Arboricultural Impact Assessment Addendum

South Wokingham Distributor Road, Wokingham, Berkshire

Arboricultural Impact Assessment Addendum

Revision: 1.4

WMHP-TG-SRWG1-DR-LS-3041

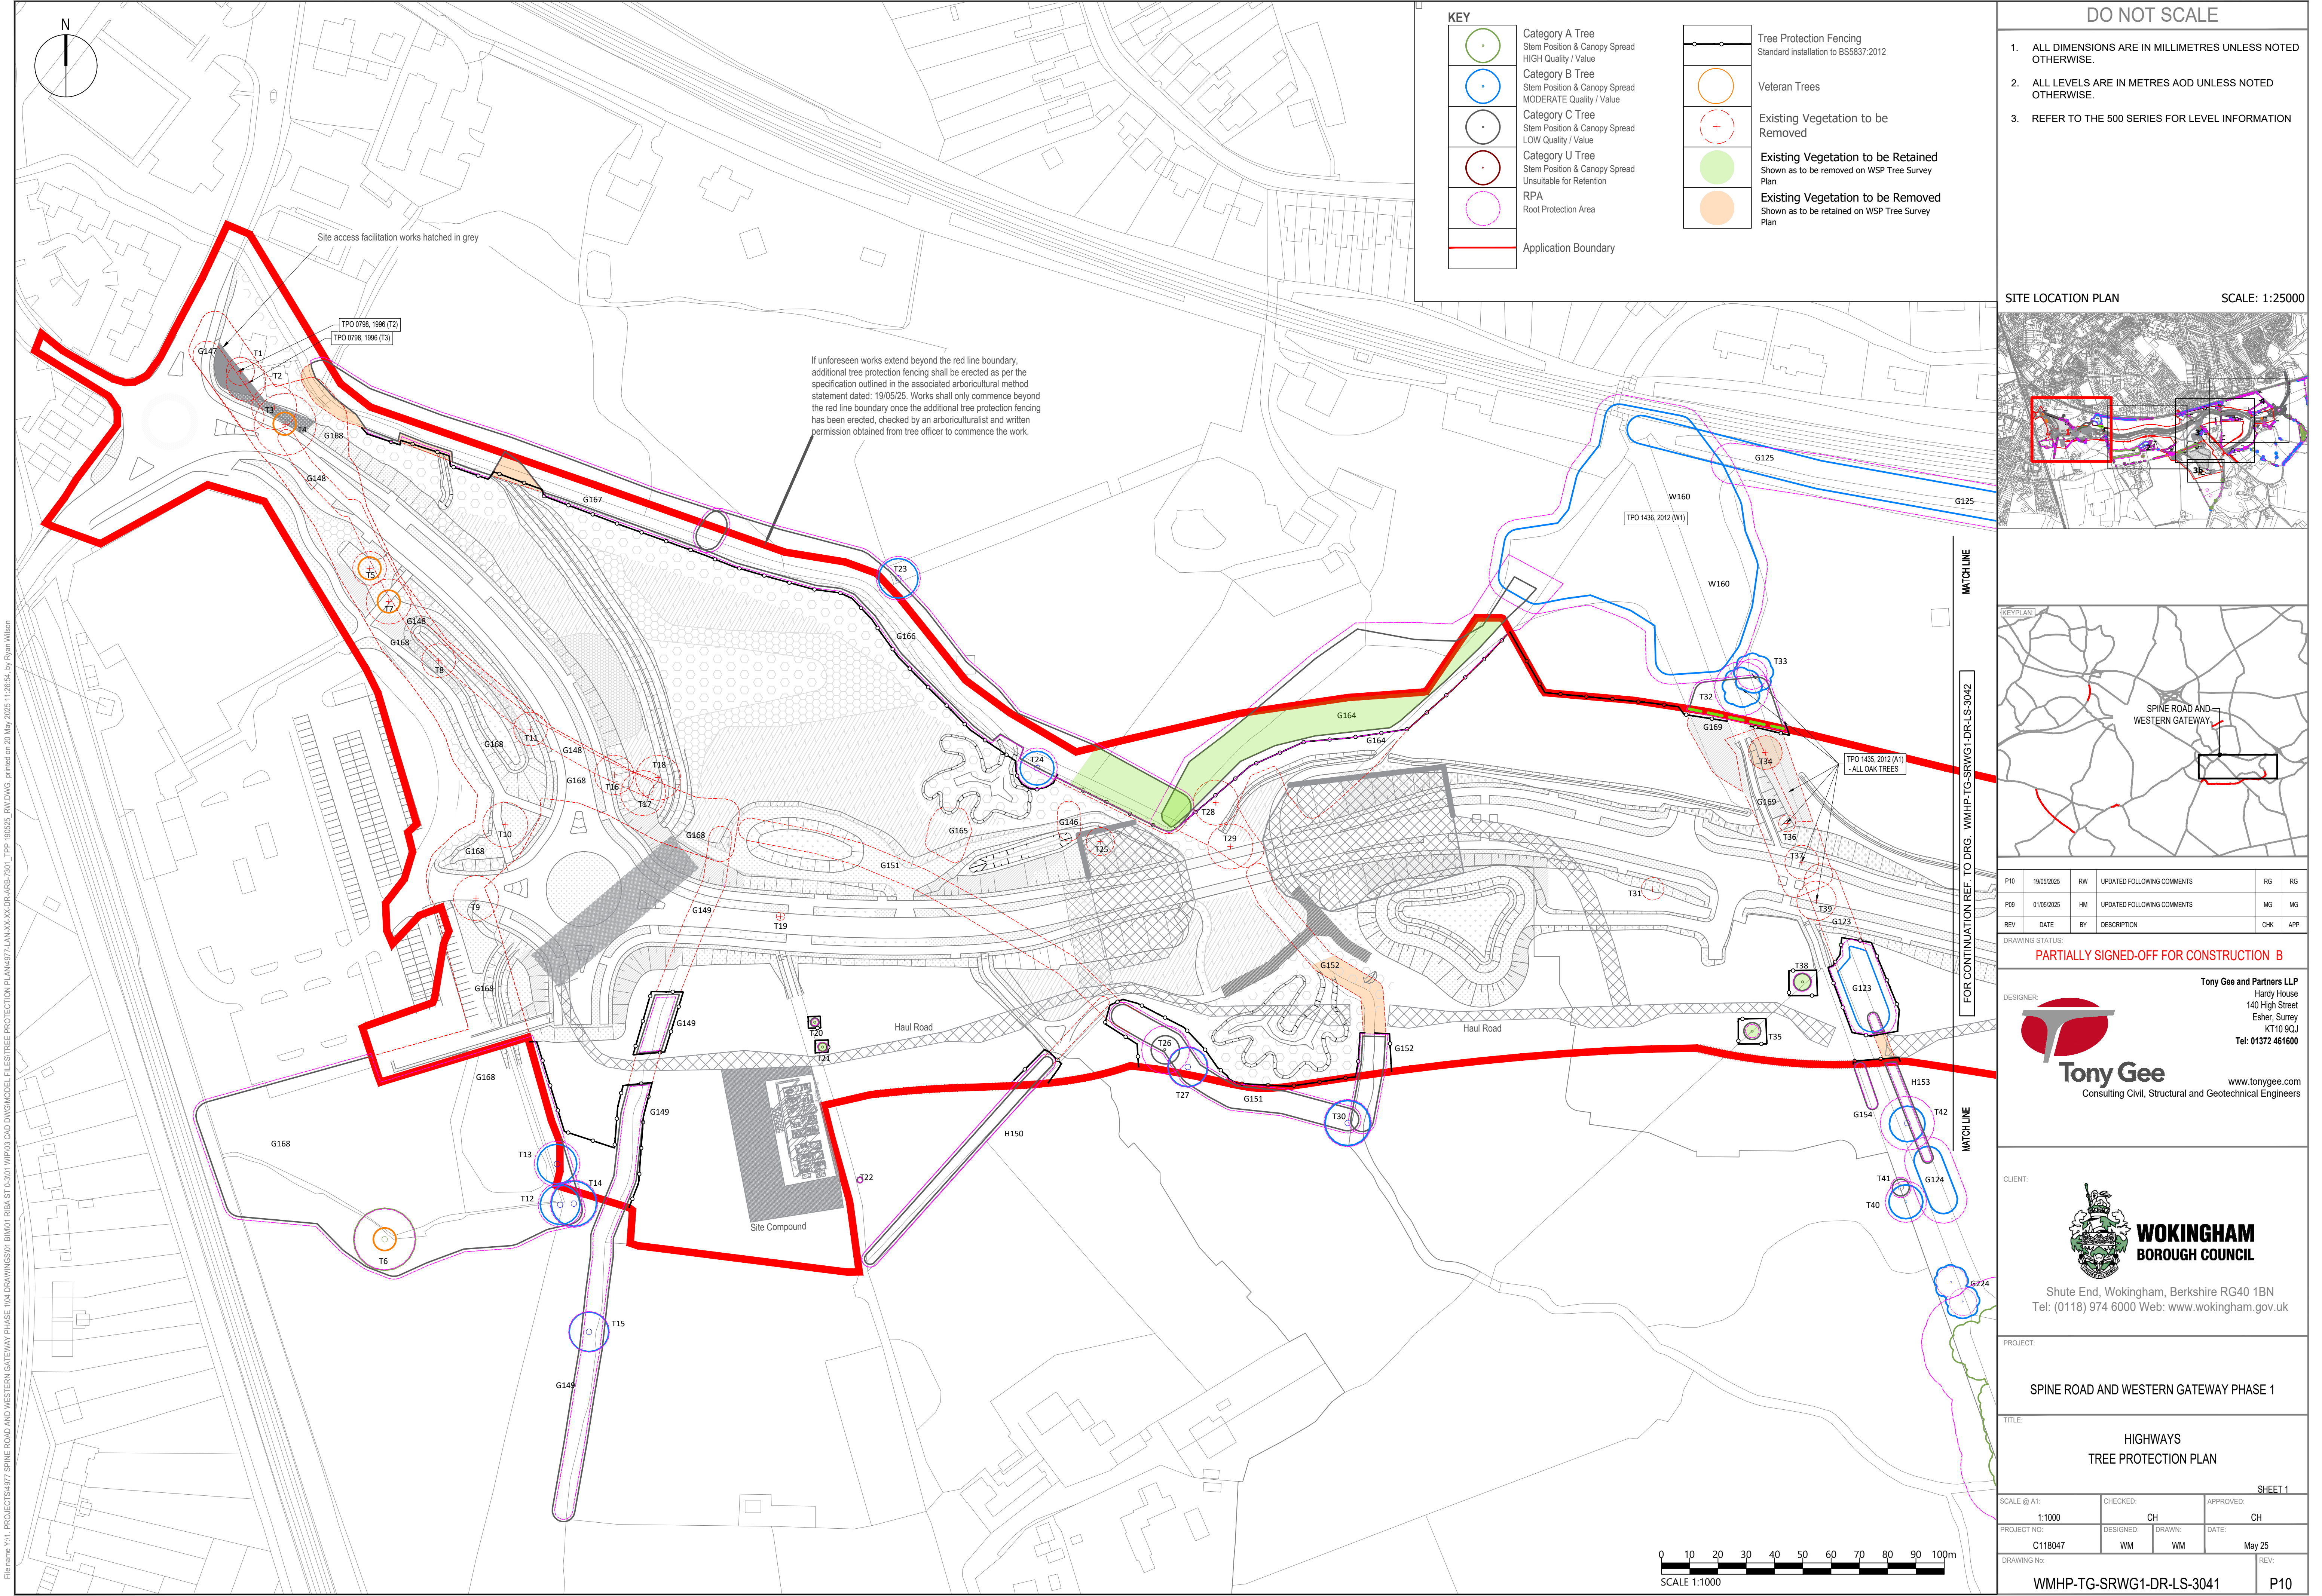
- 5.2.4 **Table 4:** Notably, T34 (Category B) and T247 (Category C) are newly marked for removal. In terms of Category C groups, G251 is now marked for removal, while two groups in Category A (G248, G249), two in Category B (G121, G159), and one Category C group (G220) were marked for full

retention are now to be partially removed. The number of hedges marked for partial removal has remained consistent, with H126 now added for removal.

WMHP-TG-SRWG1-DR-LS-3043

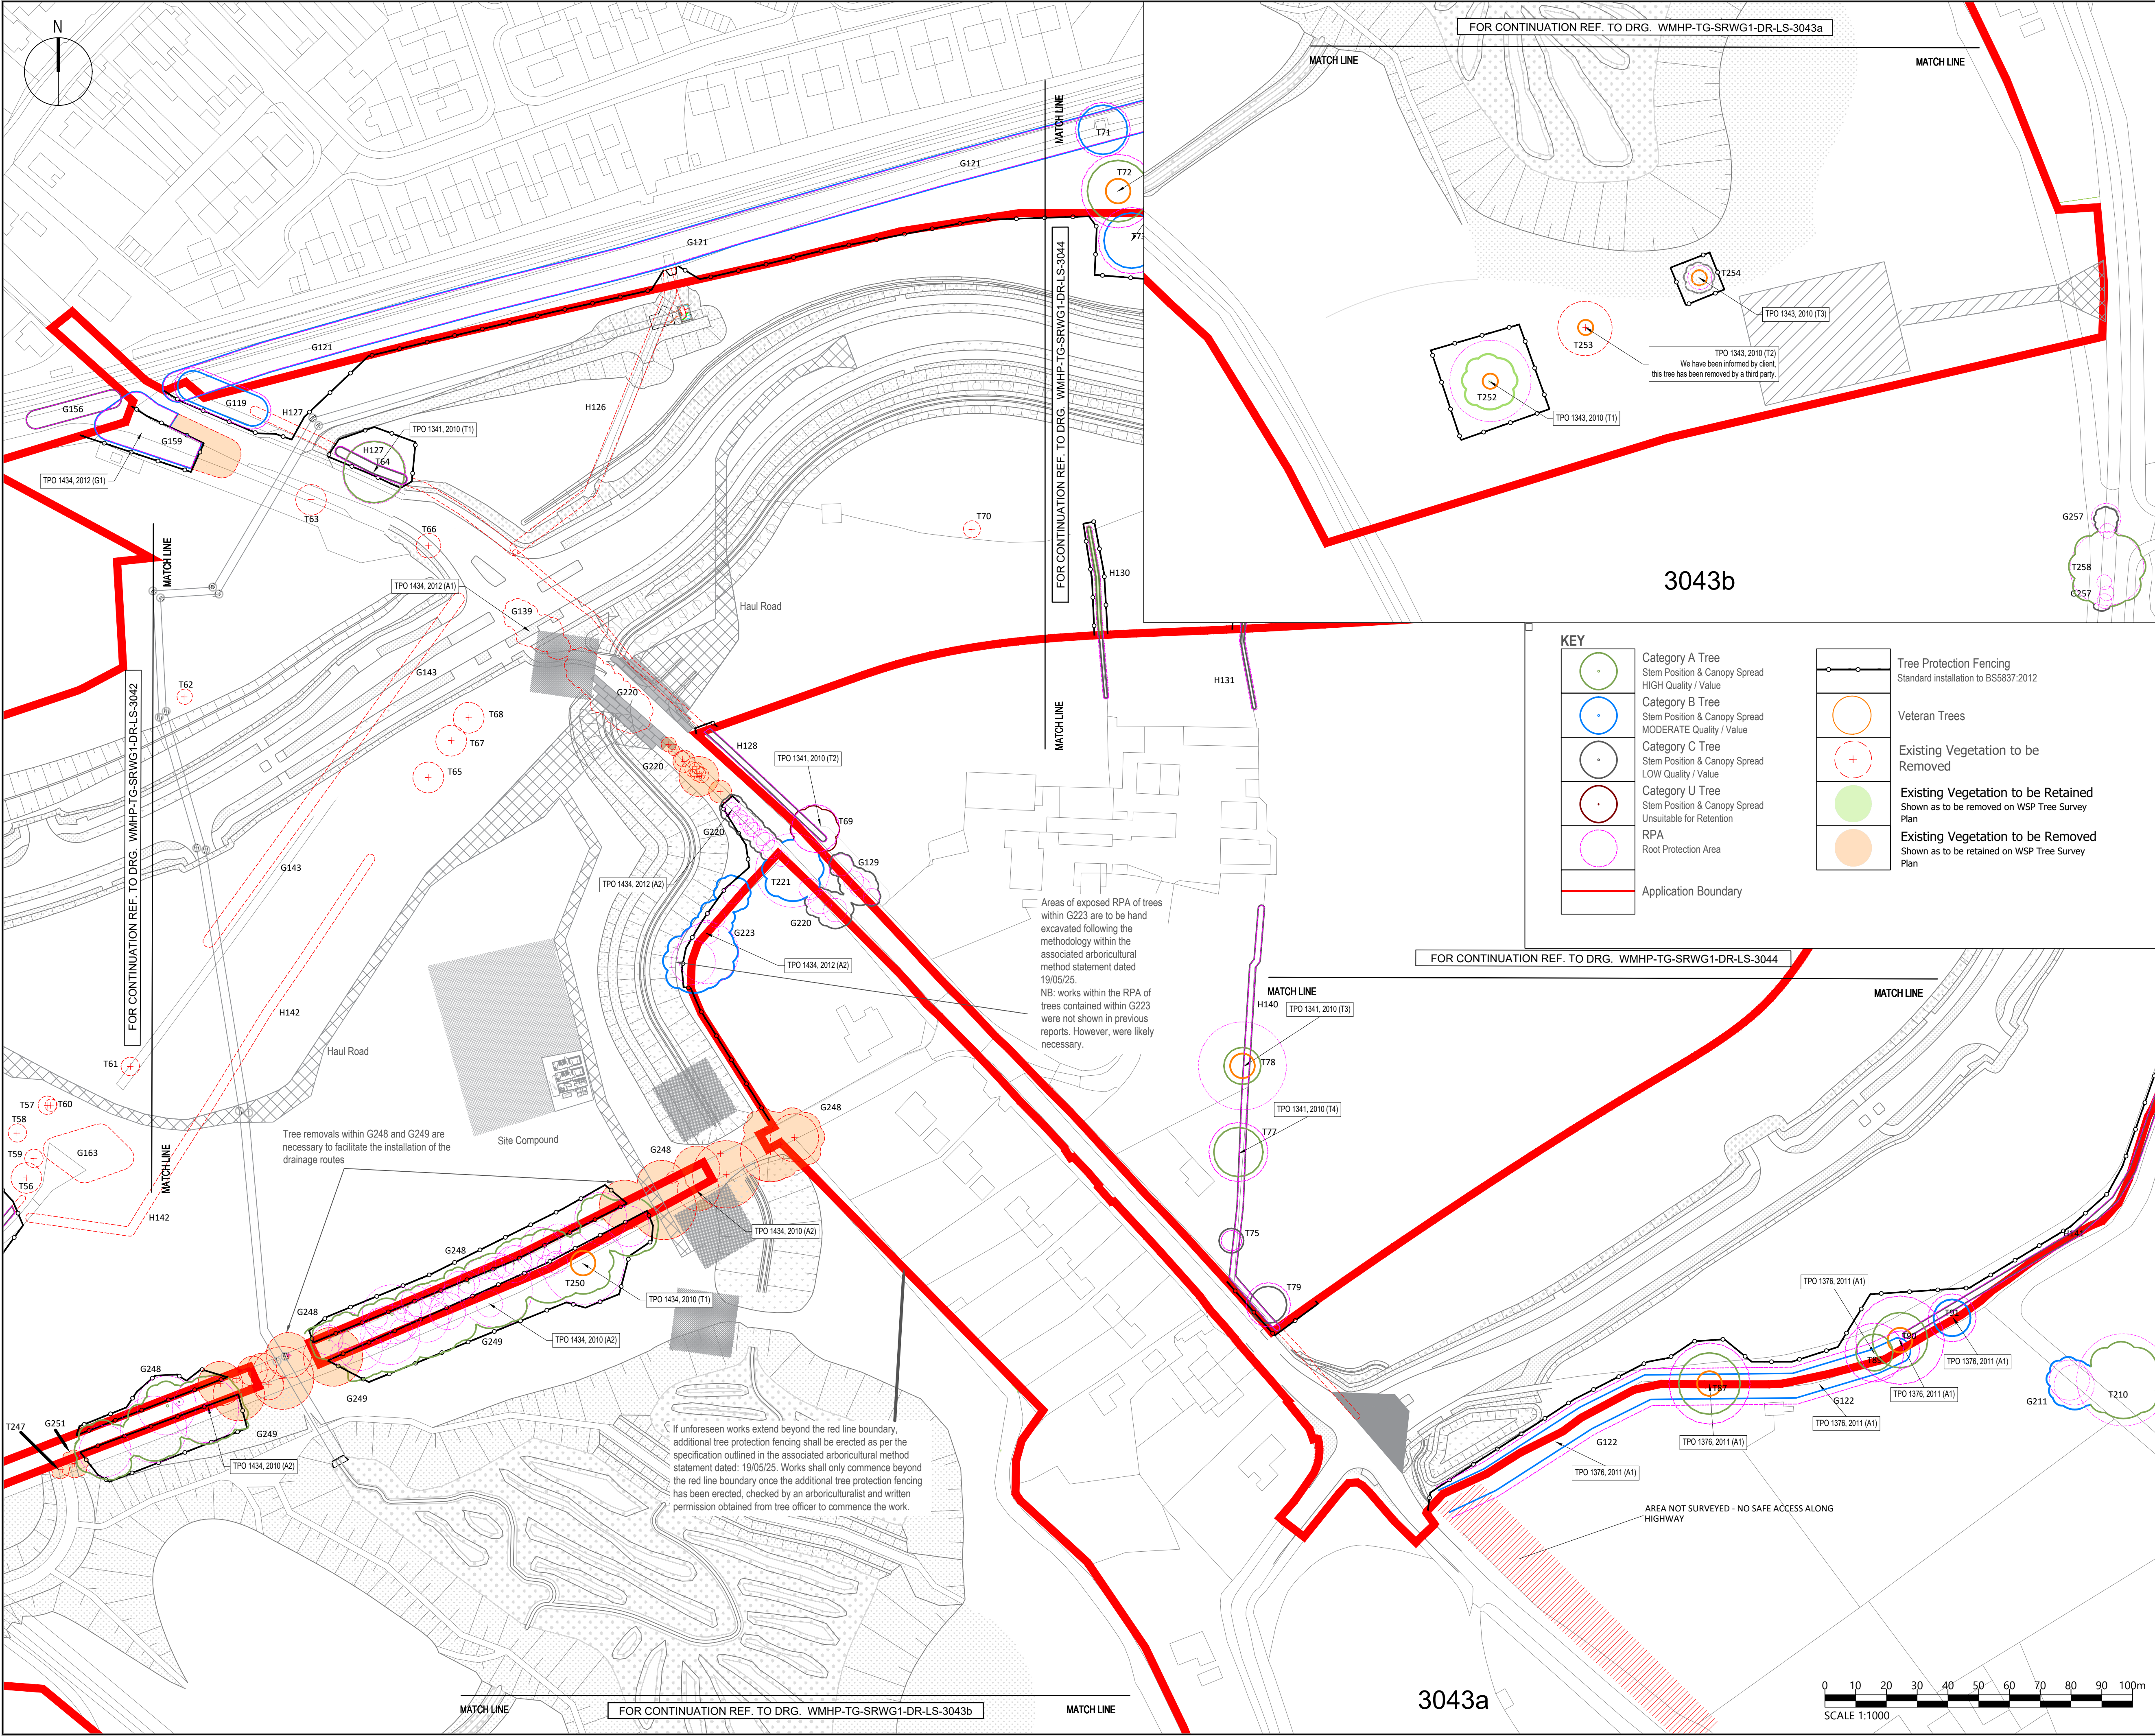
- 5.2.3 **Table 3:** Notably, 5 individual Category C trees that were previously required for removal are now retained (T20, T21, T35, T38, T54). Three hedgerows which were proposed for partial removal in WSP's AIA will maintain the same status (H130, H131 and H132).
